FIELDHOUSE USA AT AURORA TOWN CENTER

SITE PLAN AMENDMENT

COVER SHEET

FIELDHOUSE USA AT AURORA TOWN CENTER
CITY OF AURORA
SITE PLAN AMENDMENT
SITE PLAN (SE)

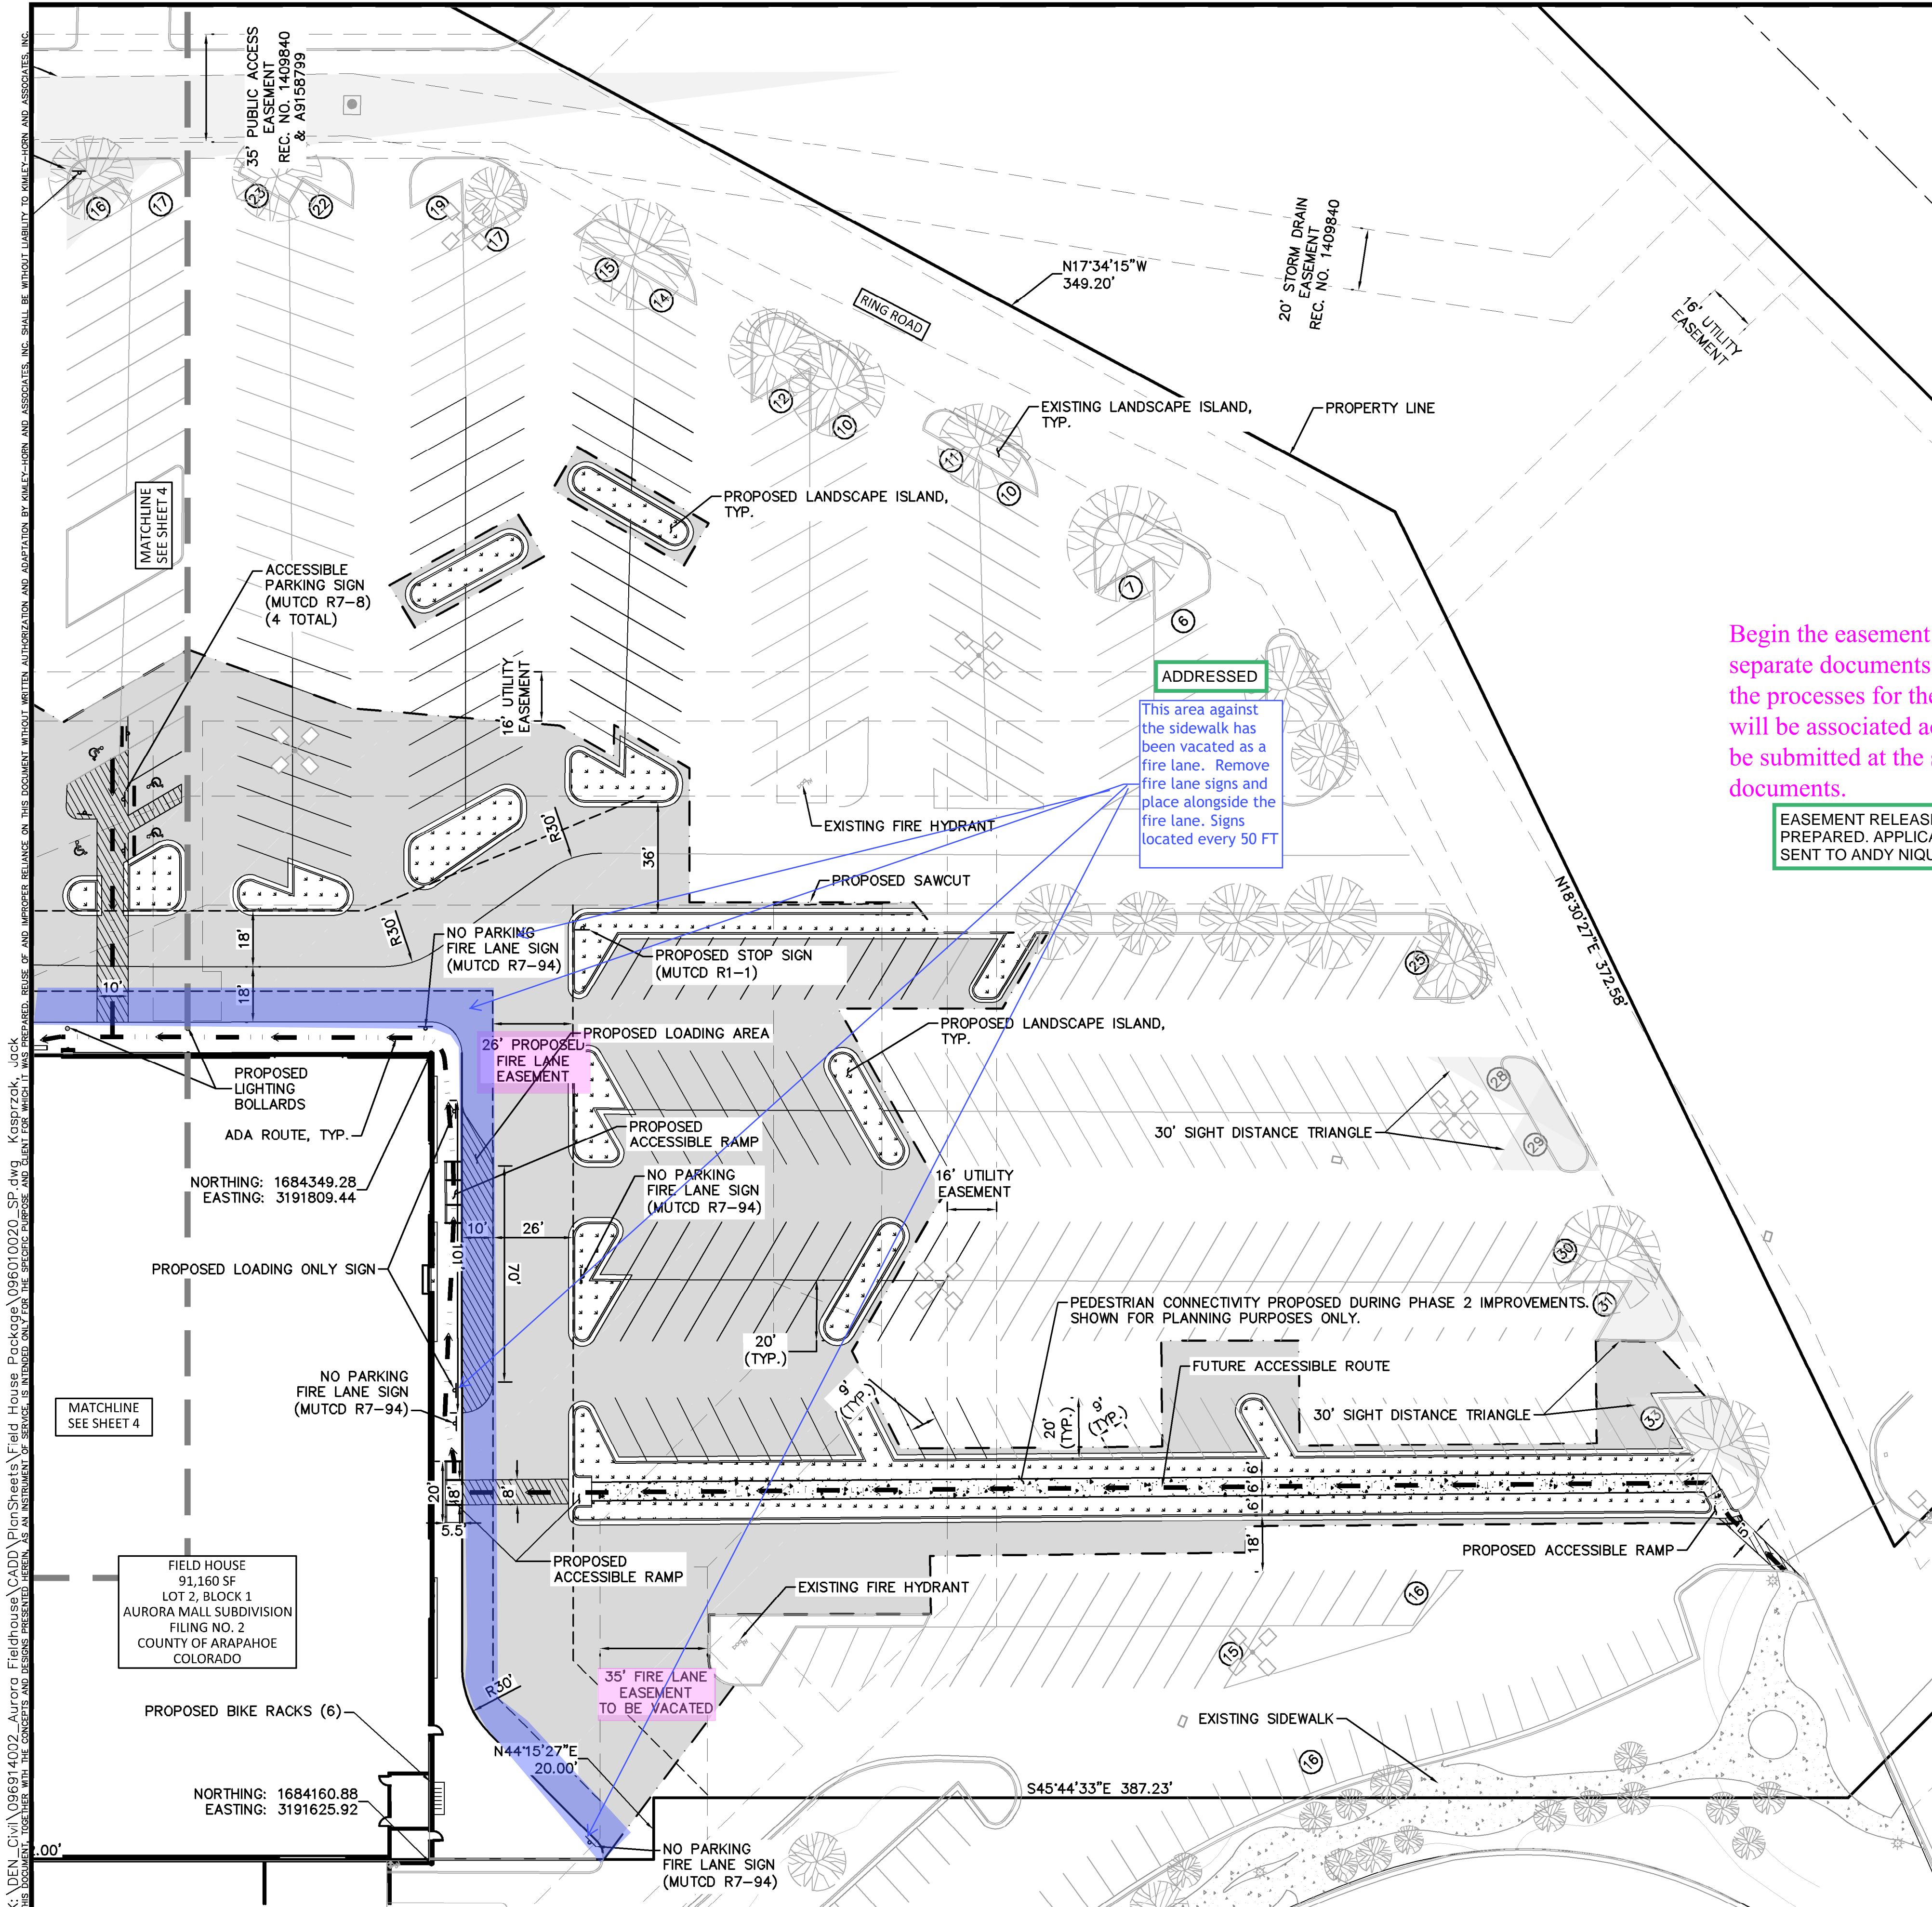
Begin the easement releases and dedications by separate documents. Contact Andy Niquette to start the processes for these easement documents. There will be associated accompanying documents need to be submitted at the same time for these separate documents.

EASEMENT RELEASES AND DEDICATIONS HAVE BEEN PREPARED. APPLICATIONS AND PACKAGES HAVE BEEN SENT TO ANDY NIQUETTE.

FIELDHOUSE USA AT AURORA TOWN CENTER
CITY OF AURORA
SITE PLAN AMENDMENT
SITE PLAN (NW)

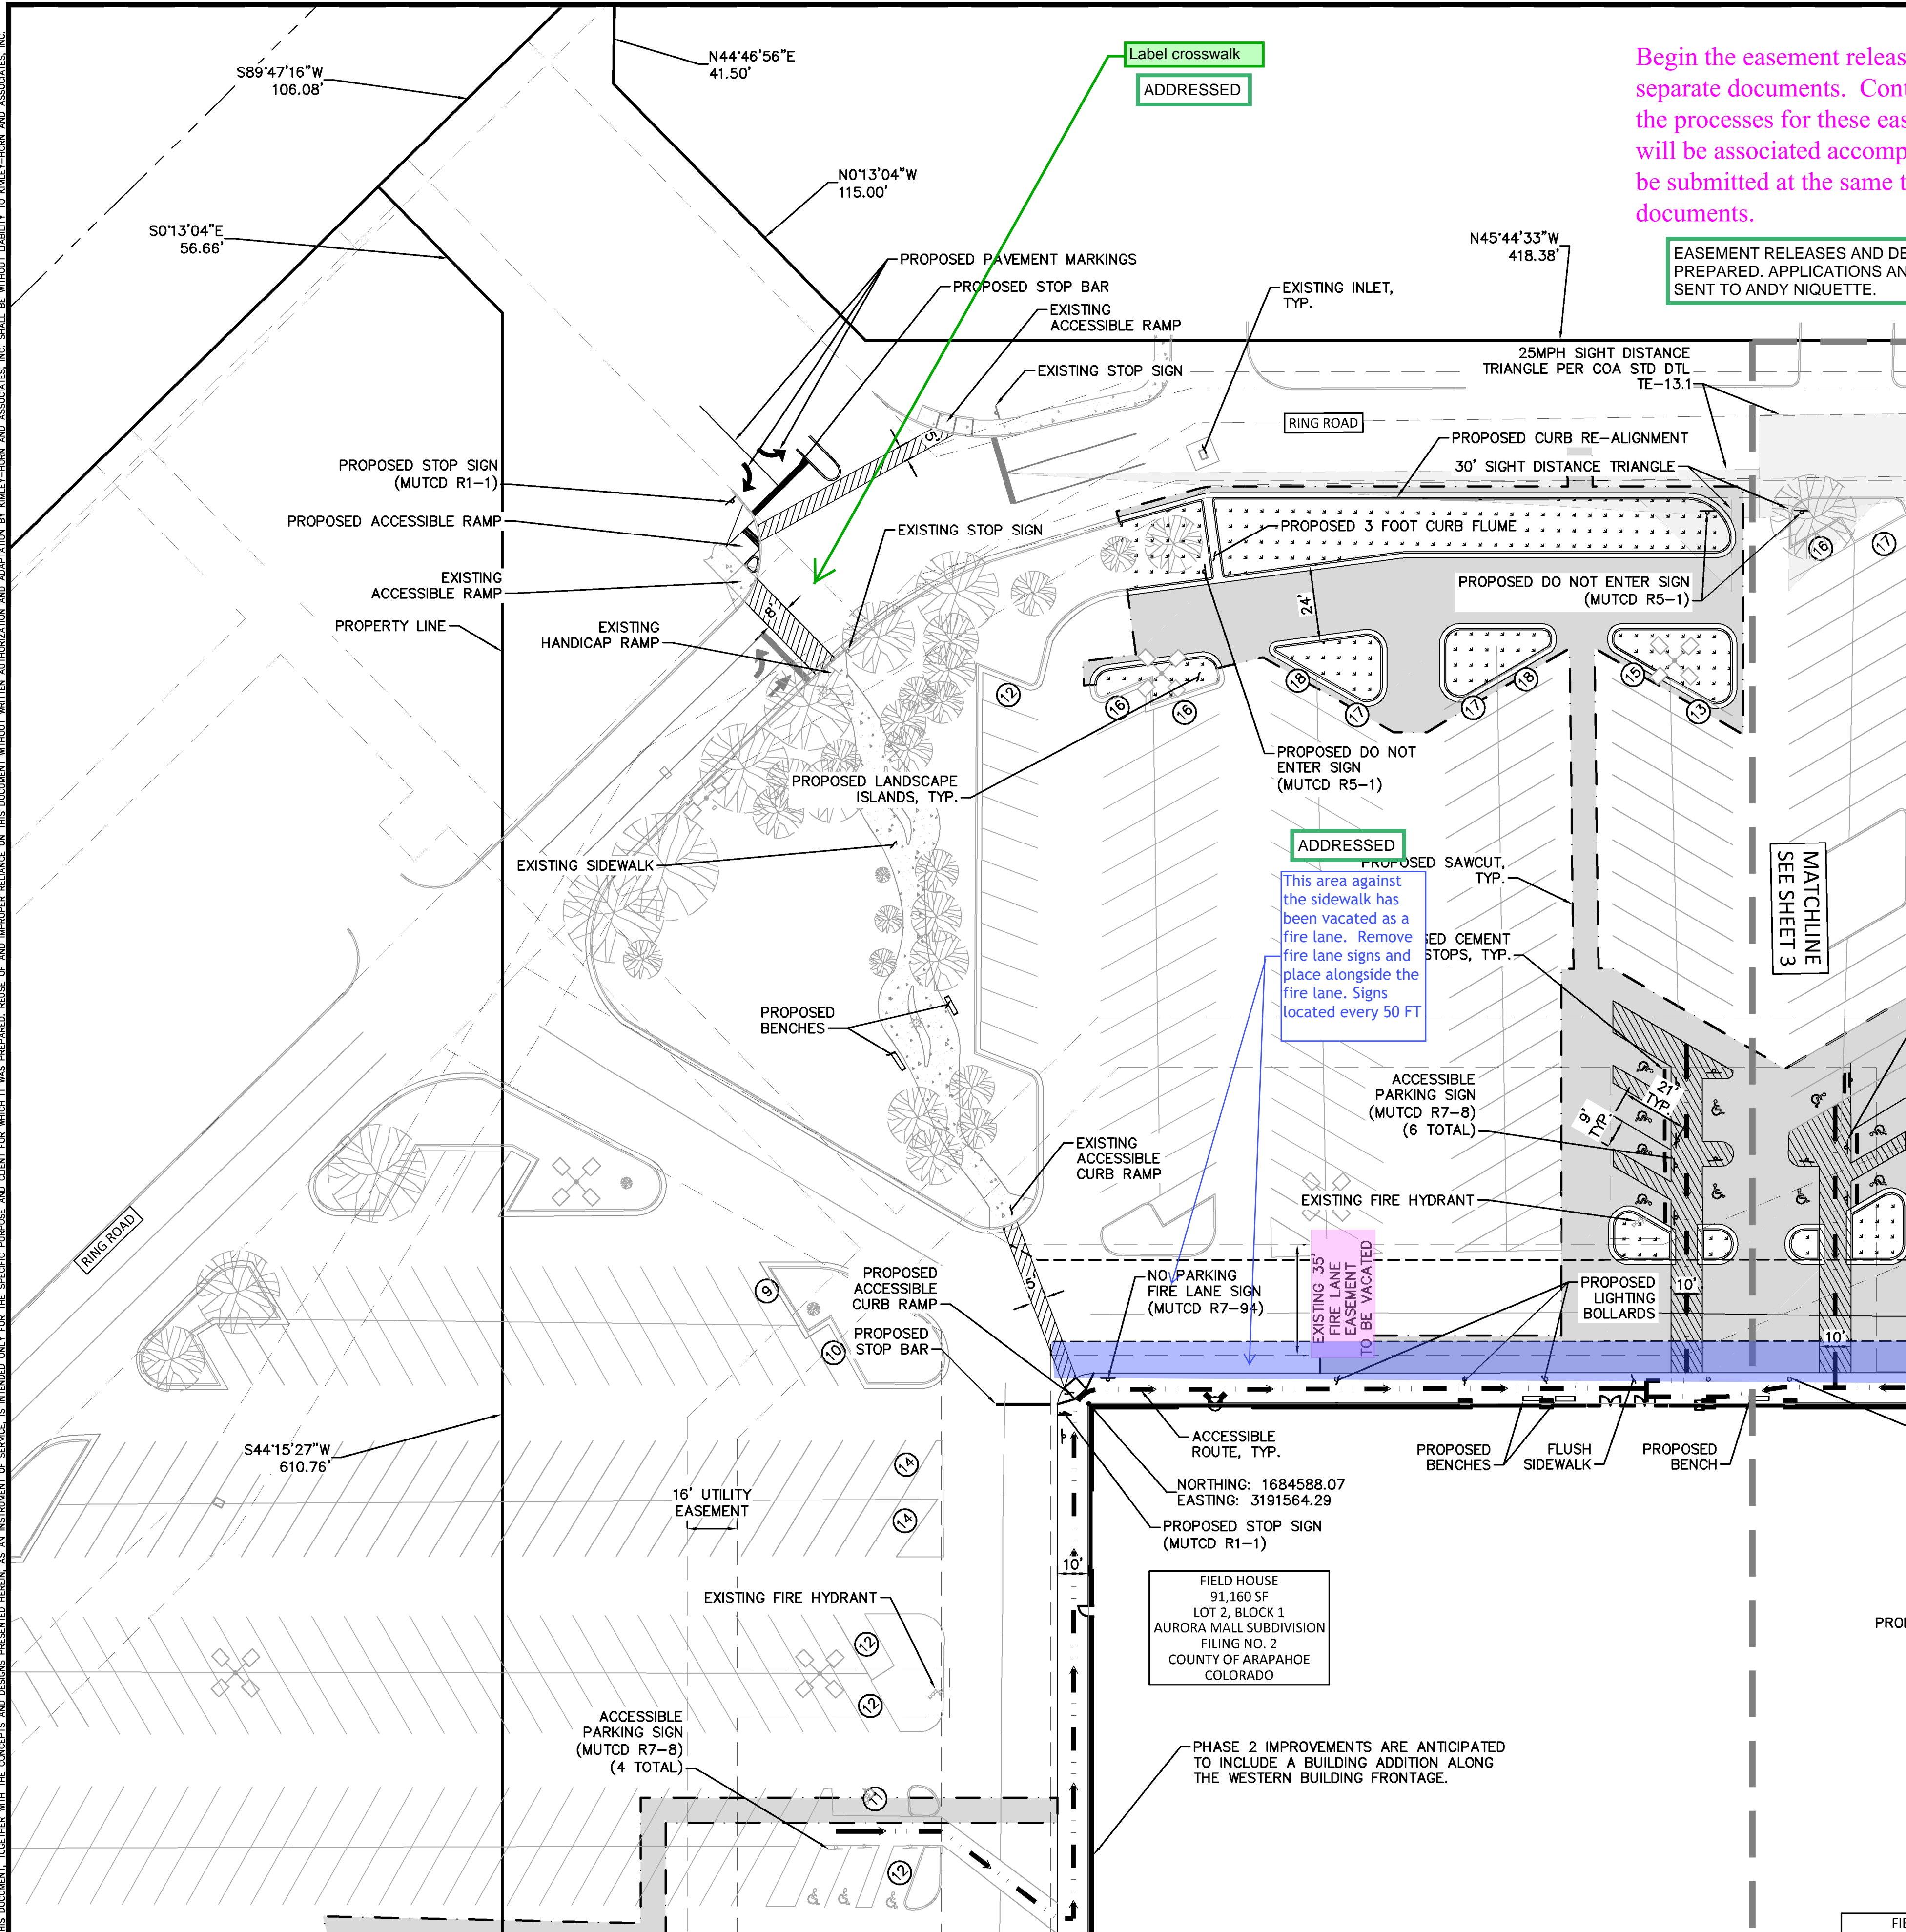
Begin the easement releases and dedications by separate documents. Contact Andy Niquette to start the processes for these easement documents. There will be associated accompanying documents need to be submitted at the same time for these separate documents.

EASEMENT RELEASES AND DEDICATIONS HAVE BEEN PREPARED. APPLICATIONS AND PACKAGES HAVE BEEN SENT TO ANDY NIQUETTE.

FIELDHOUSE USA AT AURORA TOWN CENTER
CITY OF AURORA
SITE PLAN AMENDMENT
SITE DETAILS

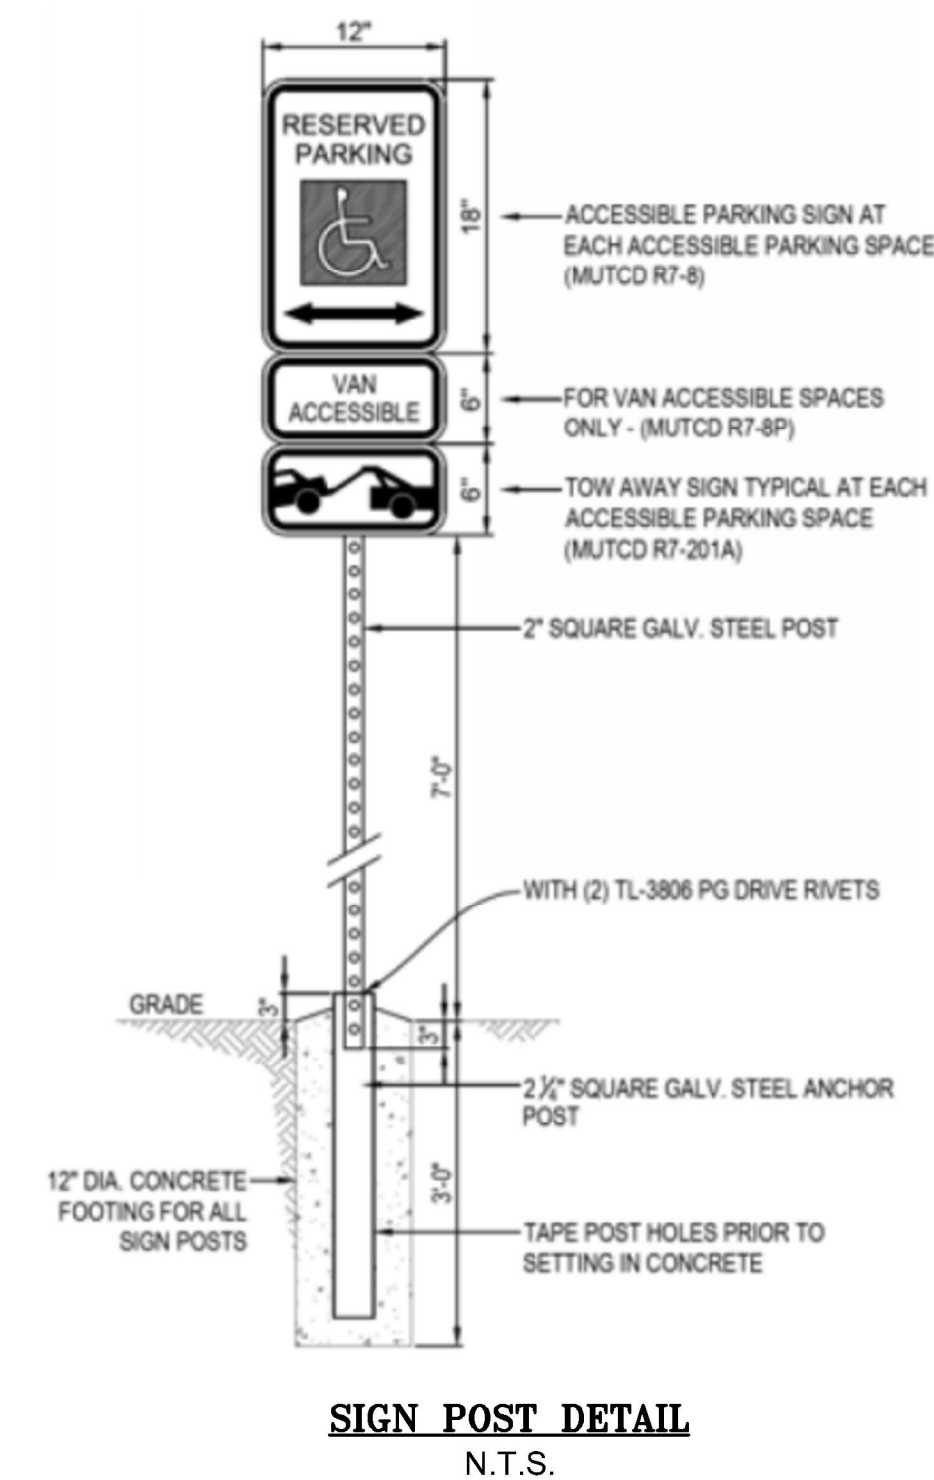
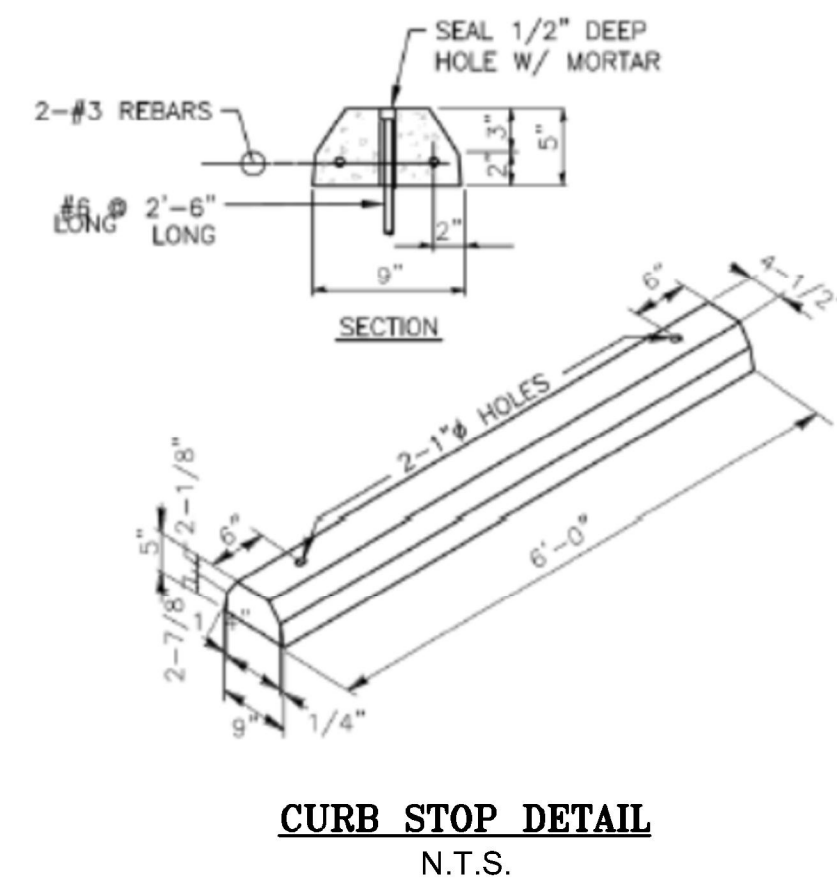
Replace sign detail with approved detail shown on sheet 10 of 19 and on this sheet.
